**GOVERNMENT OF THE DISTRICT OF COLUMBIA
DEPARTMENT OF GENERAL SERVICES**

**RENOVATION OF
2850 NEW YORK AVENUE, NE**

Solicitation No.: DCAM-12-CS-0127

**Addendum No. 6
Issued: May 2, 2013**

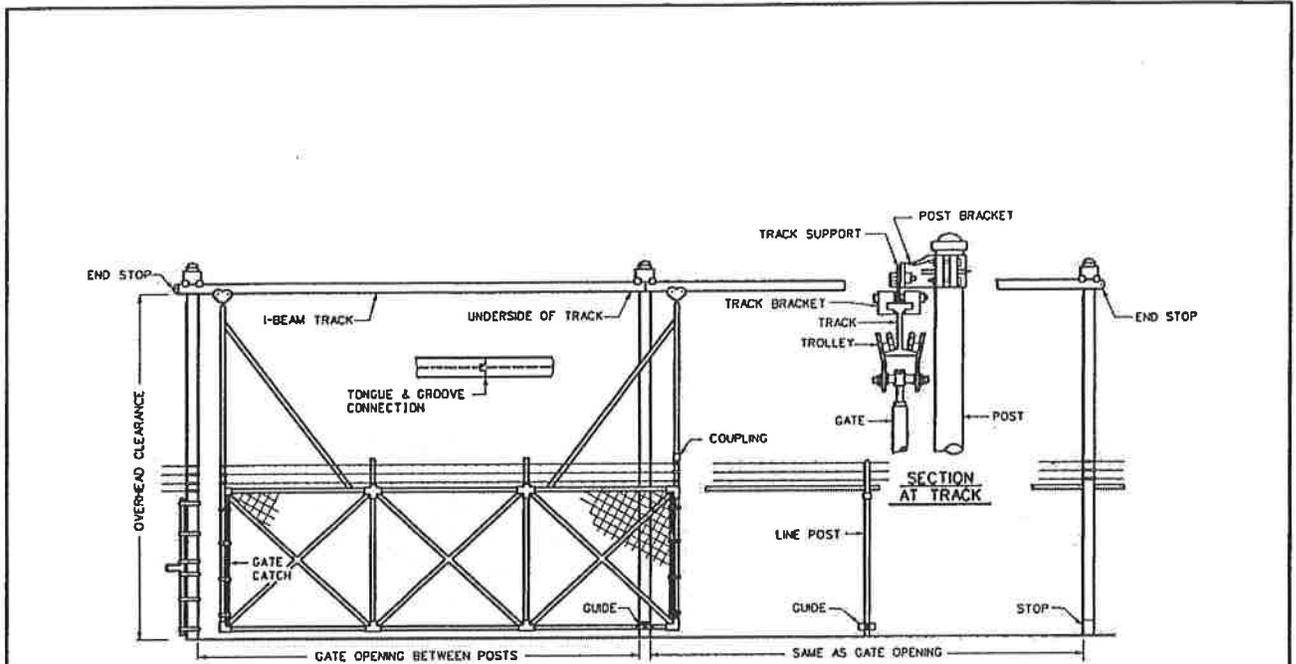
Q-13. Fire alarm notes on drawing FA502 requests to connect the existing fire alarm devices to new system. What's the name of the existing fire alarm system?

Response: It appears that the existing FA control panels are proprietary of Kidde Automated Systems. Please refer to the photos below of the Fire Alarm room #1721 for reference.

DETAILS OF SLIDING GATE

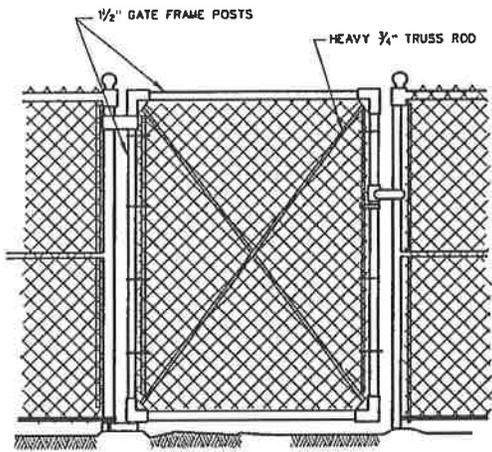
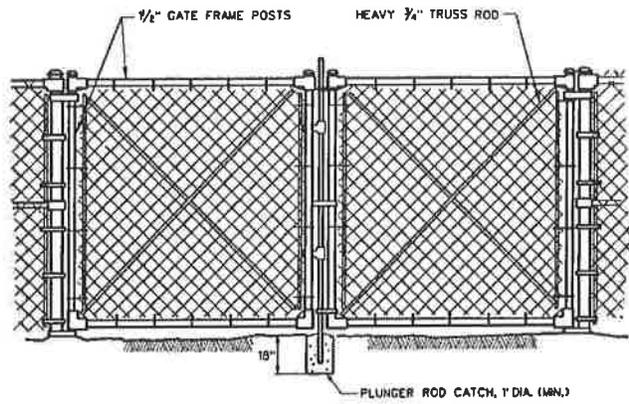
- Q-16. Please provide details and specification sections for the following:
- a. Item #14 new sliding chain-link fence gate on drawing C300
 - b. Item #1 new rubber wheel stops on drawing C300
 - c. Item #18 new wrought iron fencing on drawing C300

Response: Details for new sliding chain-link fence and new rubber wheel stops are outlined in Exhibit 1 attached. The new wrought iron fence will match the existing- see photo below.
